- Wiltshire councils SFRA which is the online arcgis, live version of the document has flooding maps that show the extent of flooding based on historic floods rather than modelled estimates.

- Despite the EA requiring a main modification in the current core strategy for Warminster that a SFRA 2 for the town be done due to the complex nature of flooding and the unknown interactions of various flood sources and topography, or the capacity and effectiveness of current flood management infrastructure to cope with current demands on it, let alone those increases due to climate change, this has not been done.

Long section through culvert

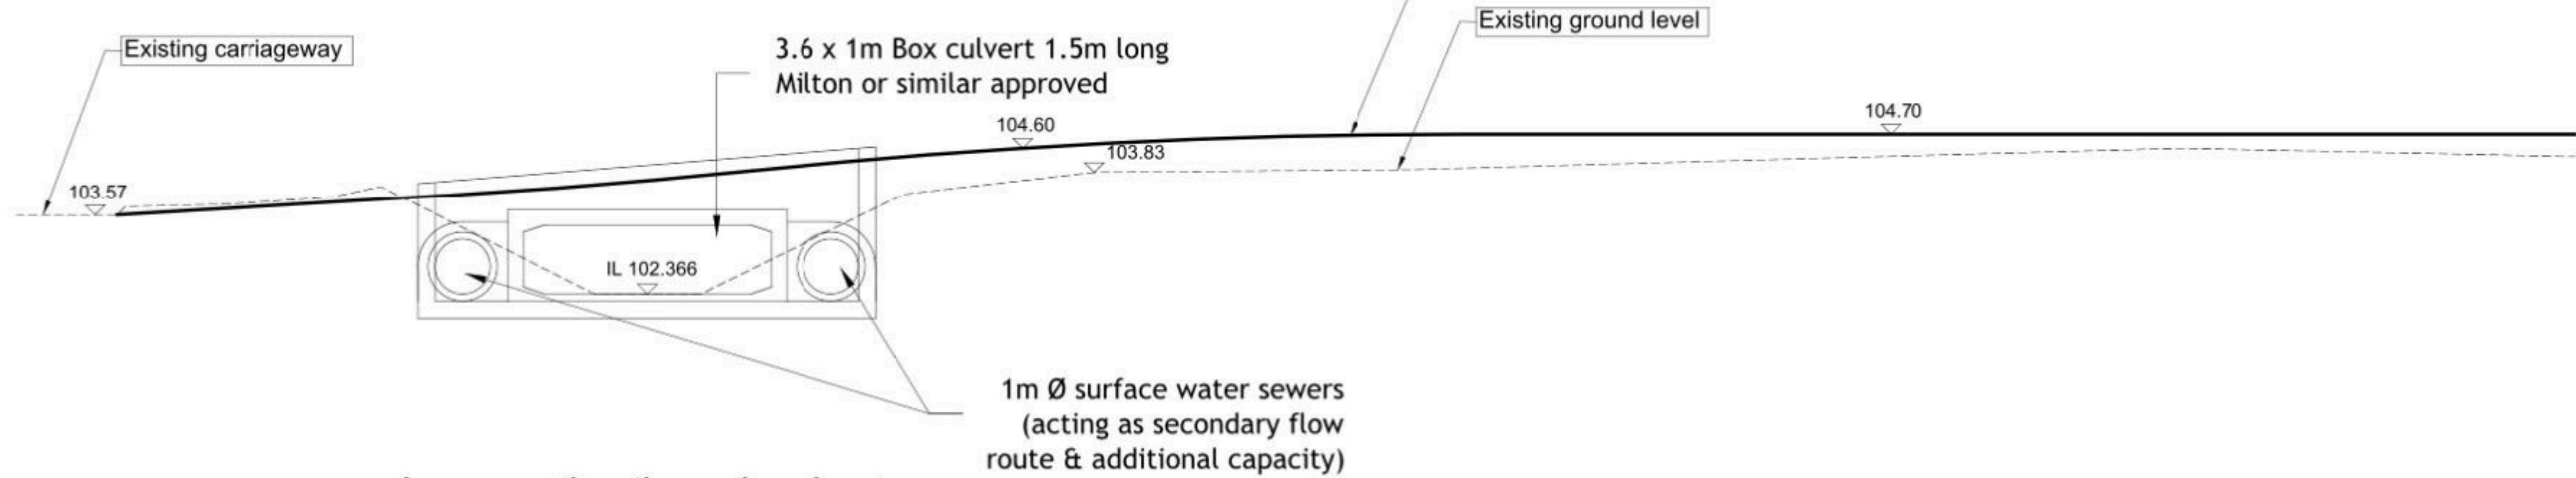
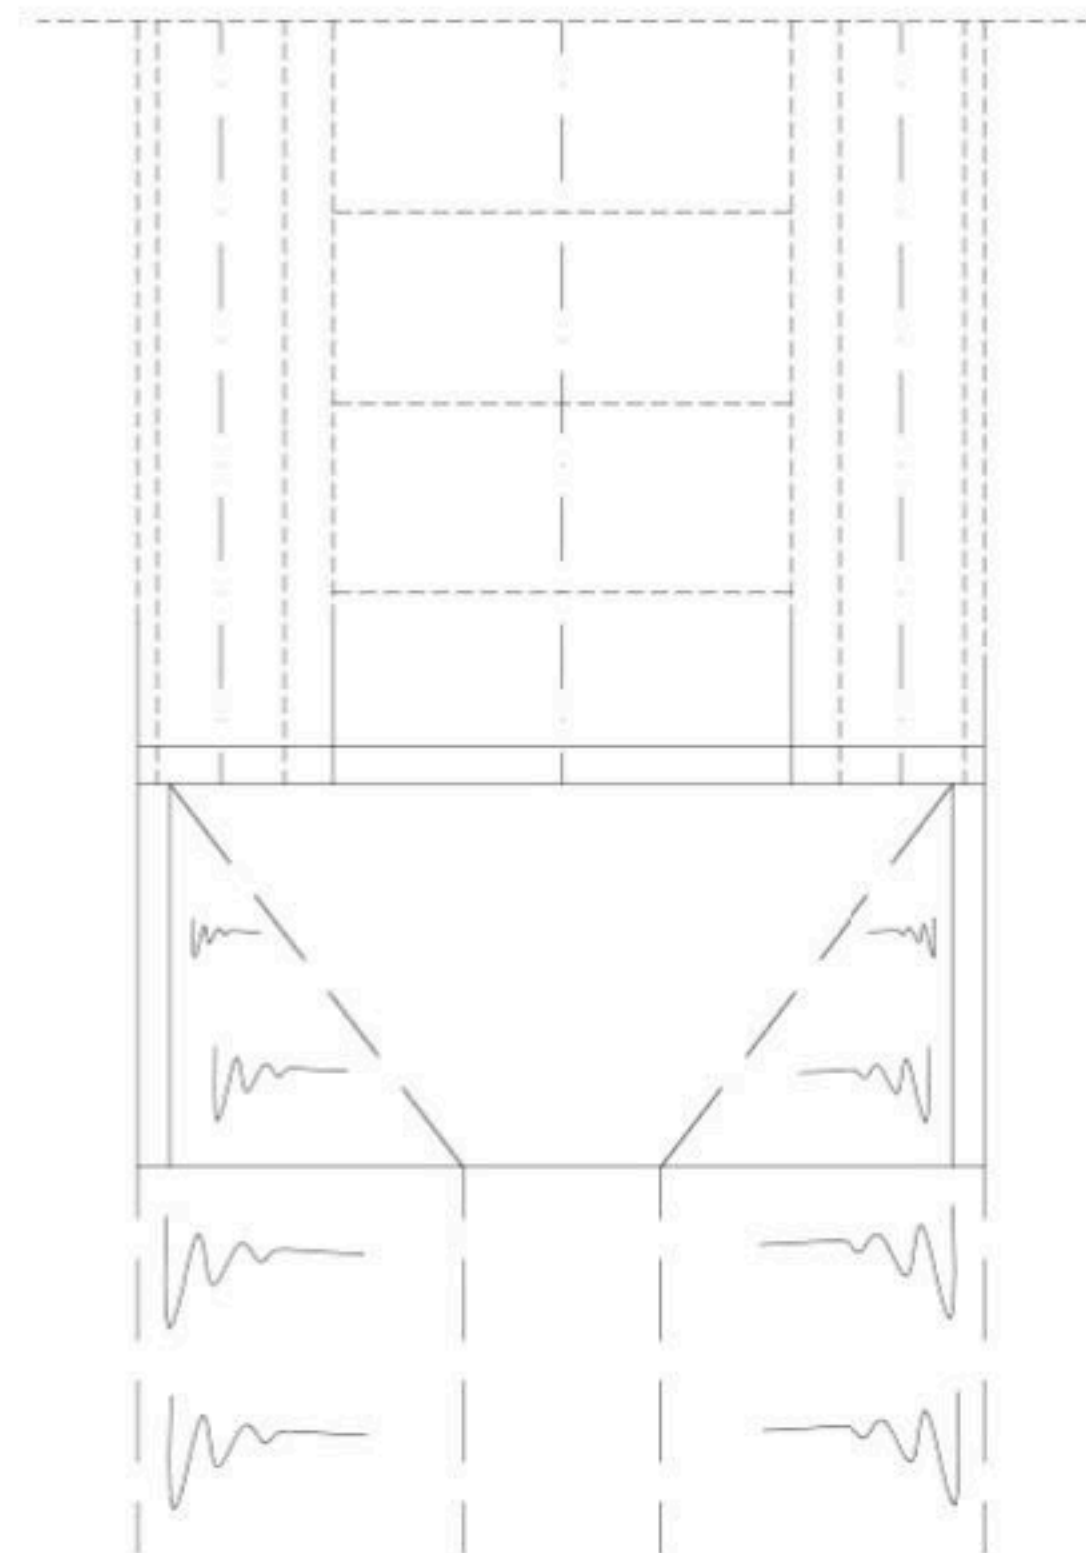
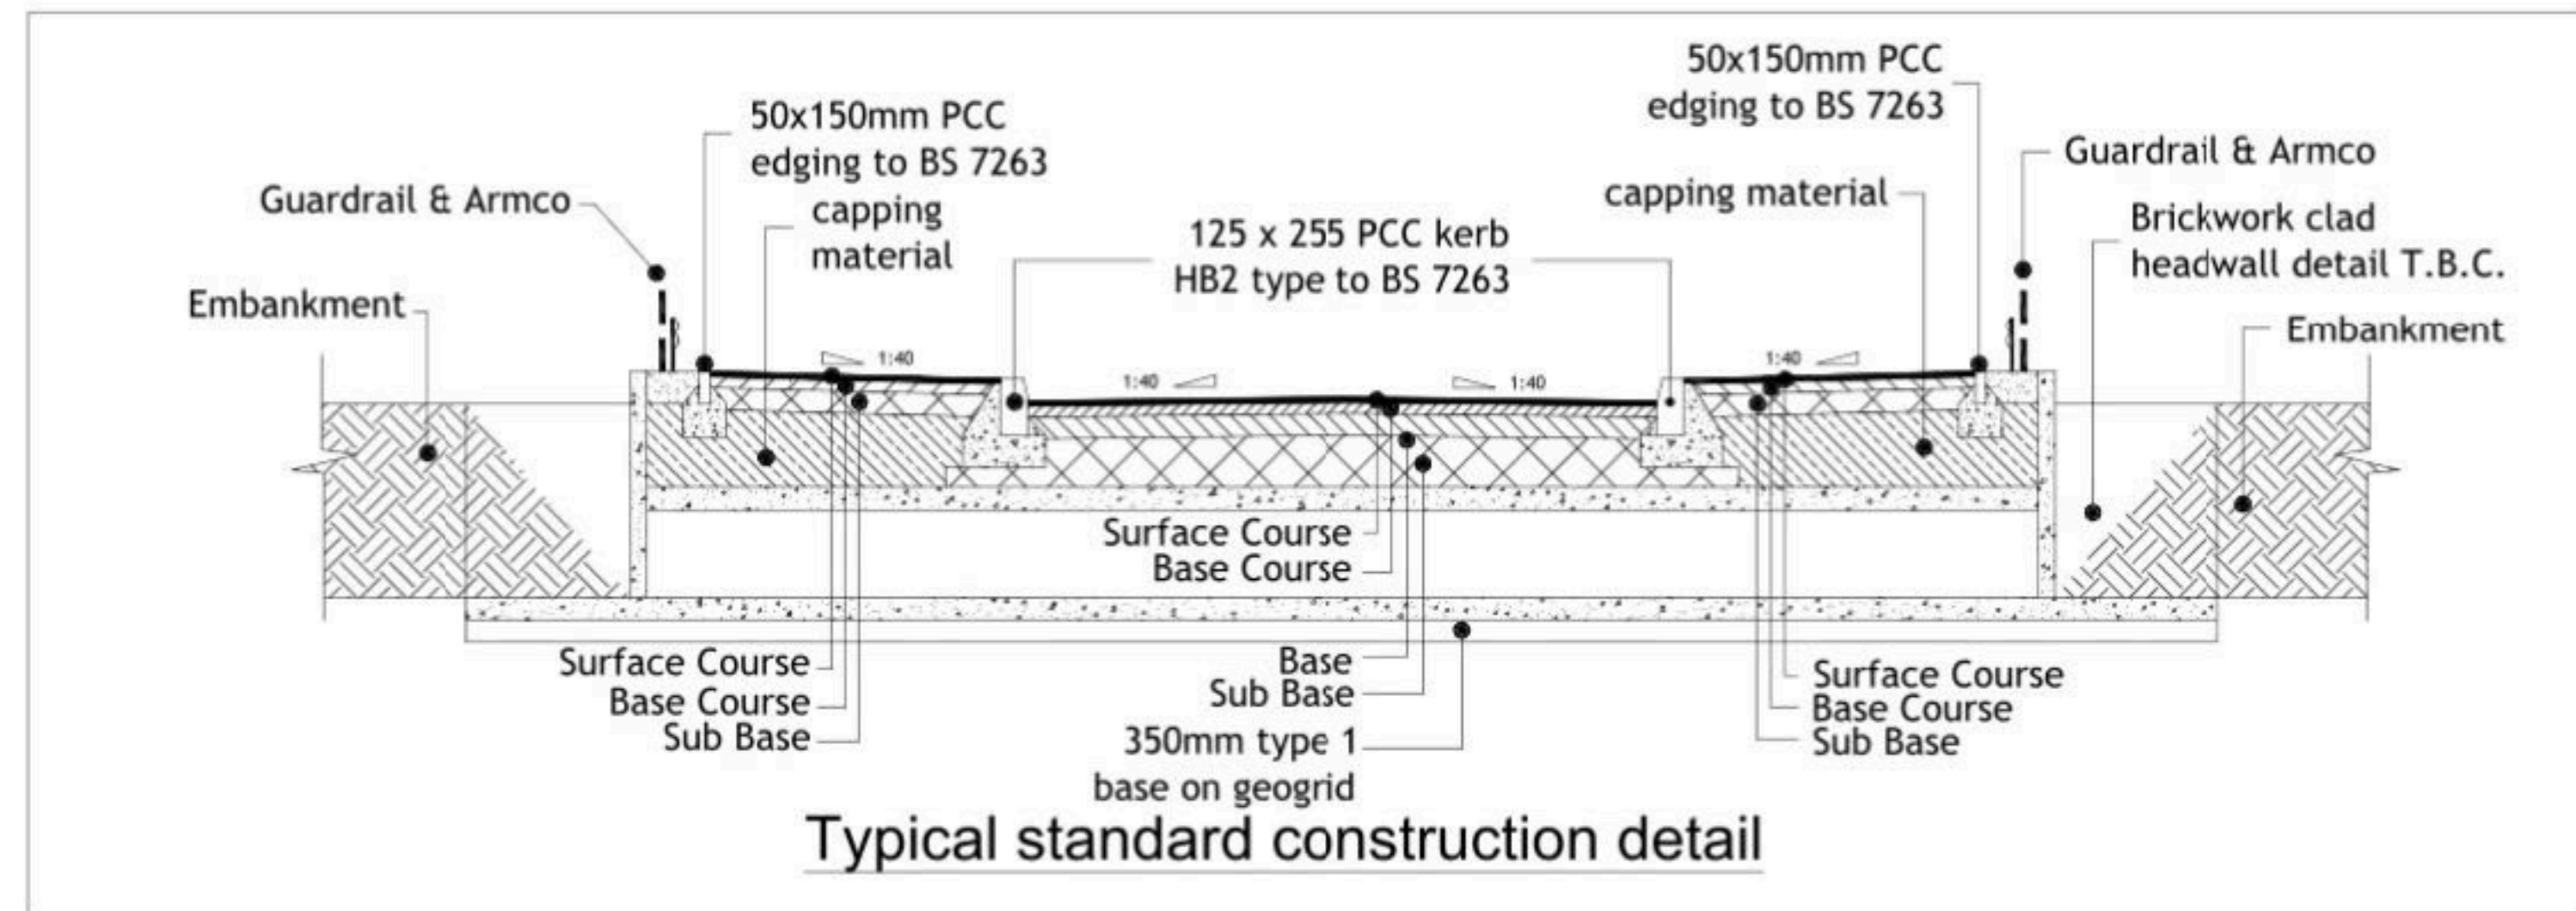
- The risk for flooding was increased further due to the council allowing the developer to change the culvert size(below) agreed upon by the EA to a much smaller one(above), based on inaccurate data provided by the developer in order to cut costs.
- The adjusted culvert went from a capacity of over 11m³/s to one of only 0.5m³/s. A drastic reduction and far too small to handle the large volumes of floodplain water now trapped in the field's behind park cottages. This culvert is so restricting that the volume of water buildup raises the flood water across the valley floor by three or more feet allowing it to enter the properties on Boreham rd despite their raised positions.

- The above map shows the size of the original EA agreed culvert, which may still have not been large enough to accommodate the flood increases expected due to climate change, but would have provided much better short term movement of water down the valley.

Storm Overflow Location Details

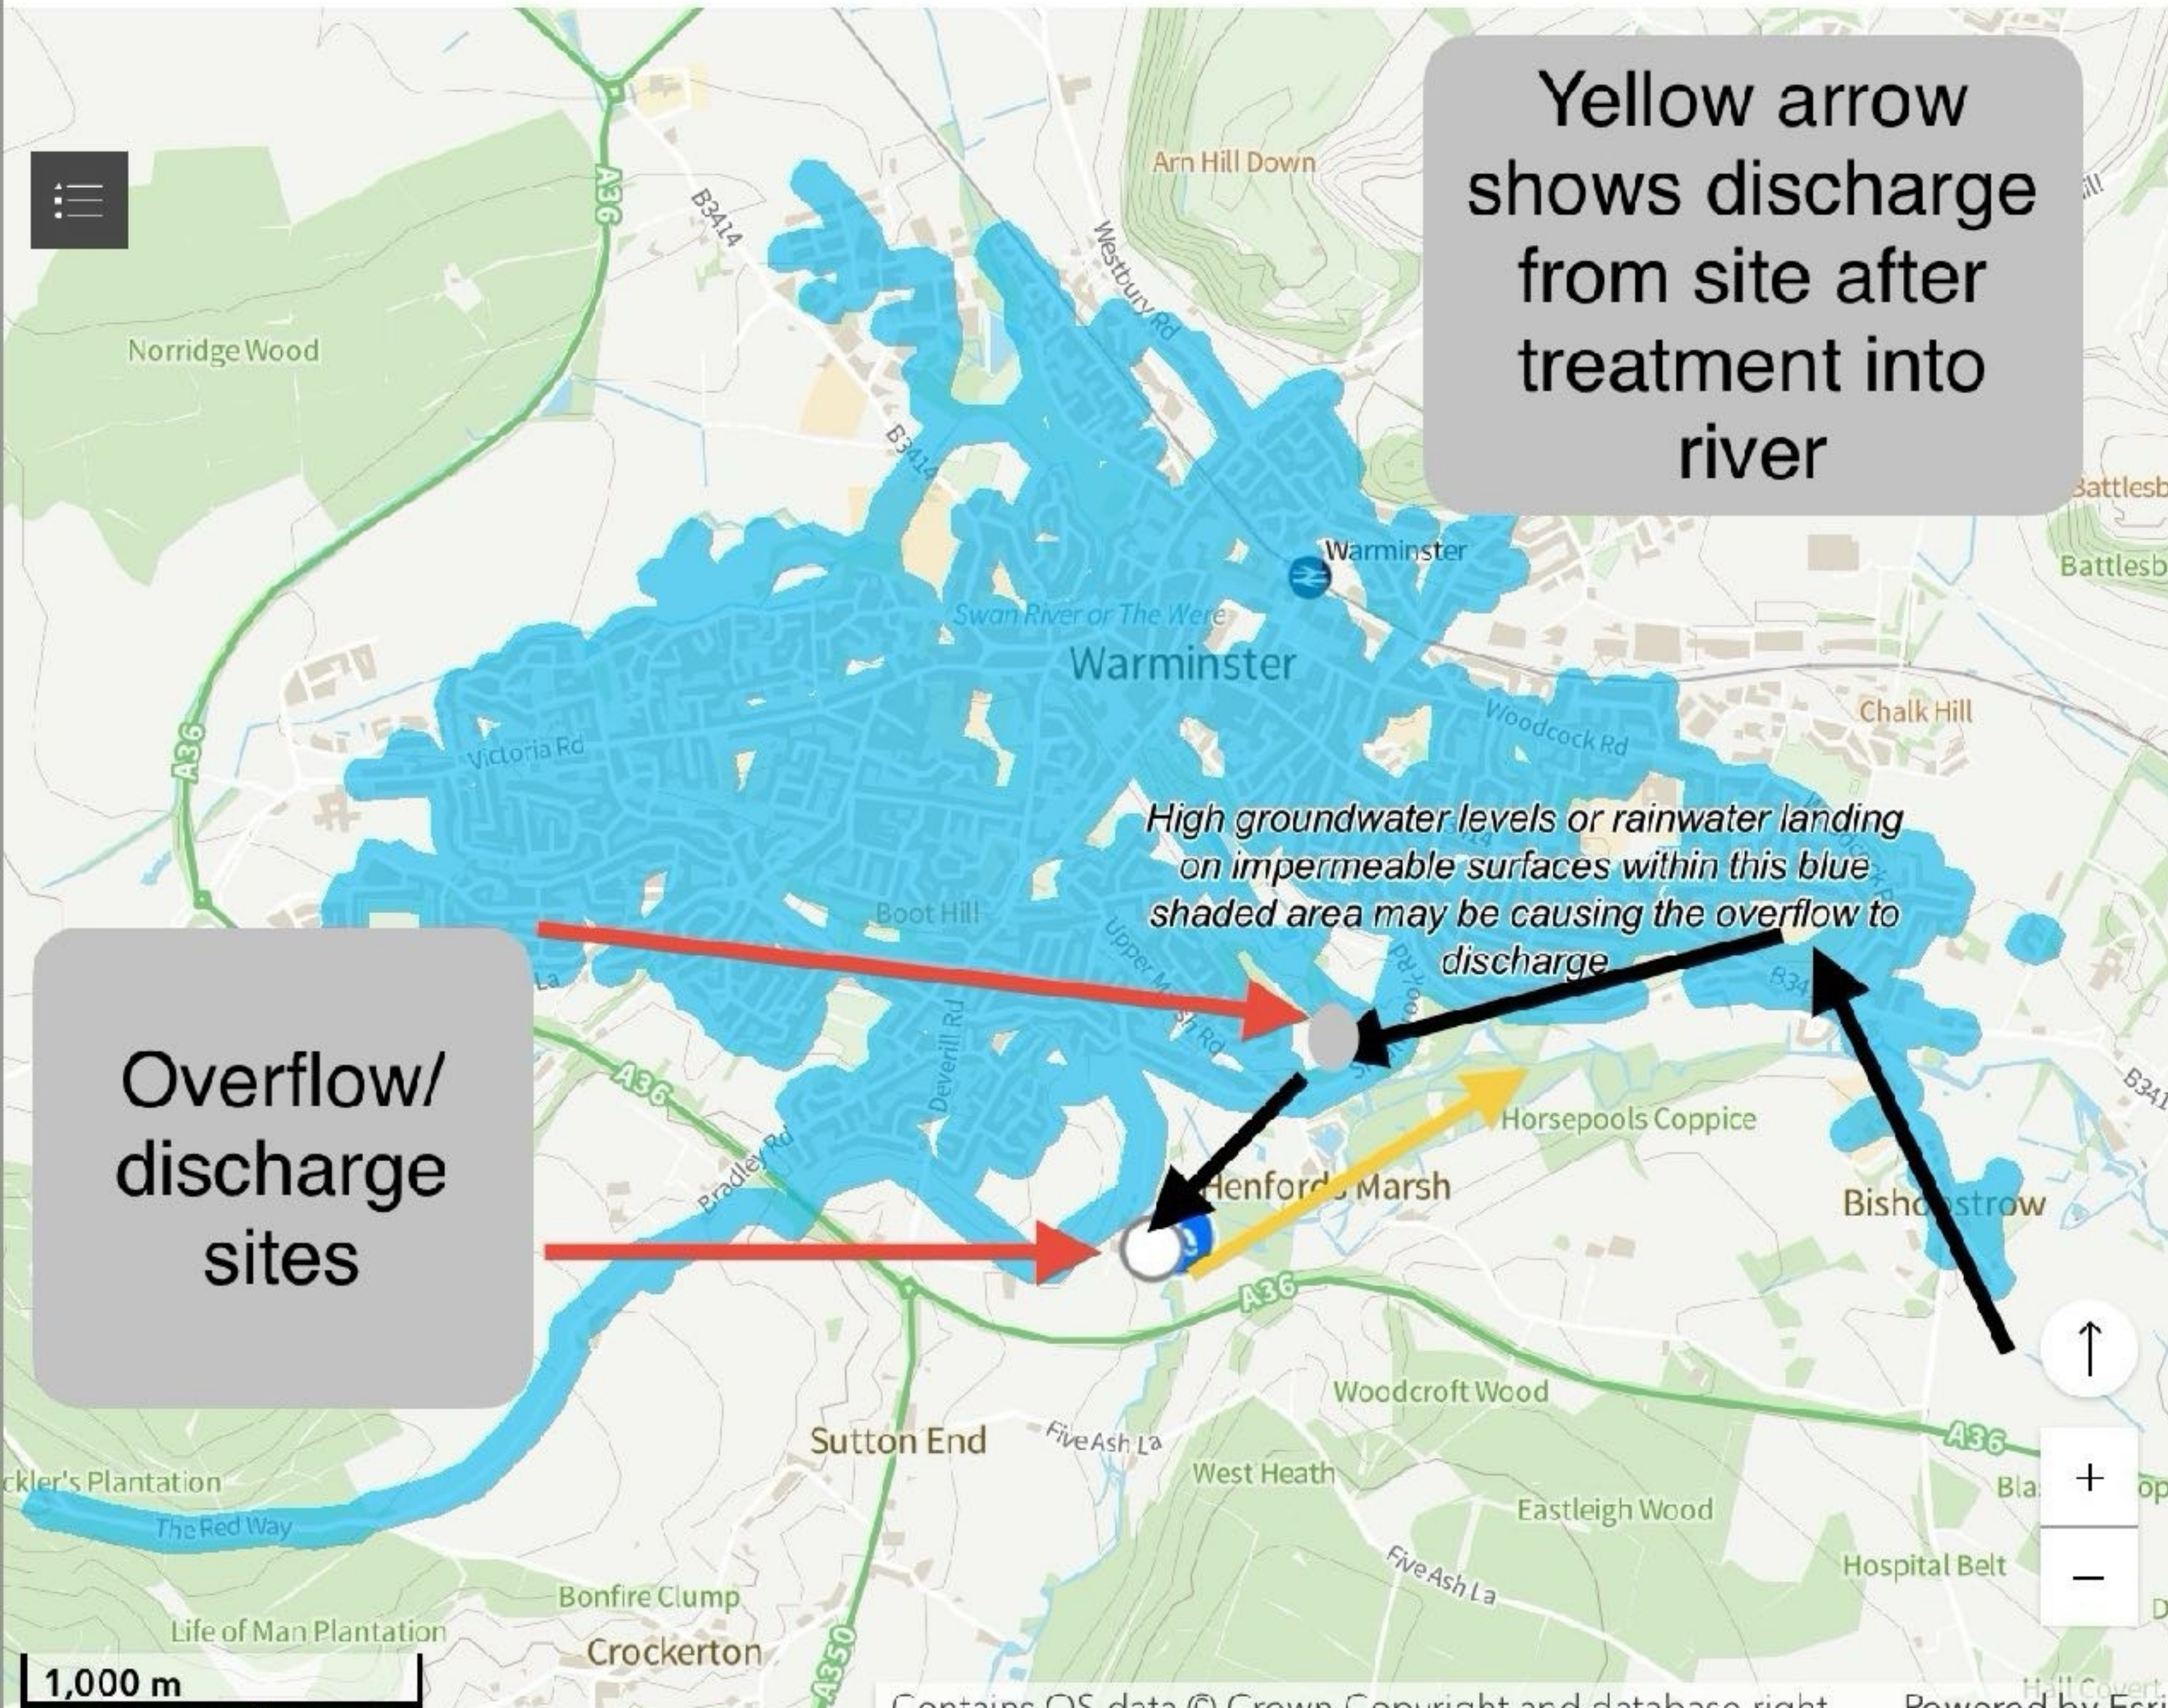
- The above map highlights the crazy situation where sewage water is pumped up hill from Bishopstrow to Boreham rd, collects discharge from most of east Warminster including Woodcock rd, Highbury park,, the dene, etc etc and is then pumped up hill to calves-water on Smallbrook rd, then on to the treatment plant at Henfords Marsh, where it and all sewage from Warminster's are treated then released into the river Wylye to flow back down hill to Boreham mead then Bishopstrow.

- So not only is Boreham mead and Bishopstrow required to handle all flood water including exceedance flows when attenuation ponds on the new estates reach capacity but also the entire towns treated sewage water which is not added to any calculation in increased flood risk yet the volume discharged is greater than surface water run off rates from green field sites which is known to increase flood risk if not controlled. Pumping water up hill to allow it to flow unchecked back down hill to cause flooding is clearly happening but being ignored but not for much longer.
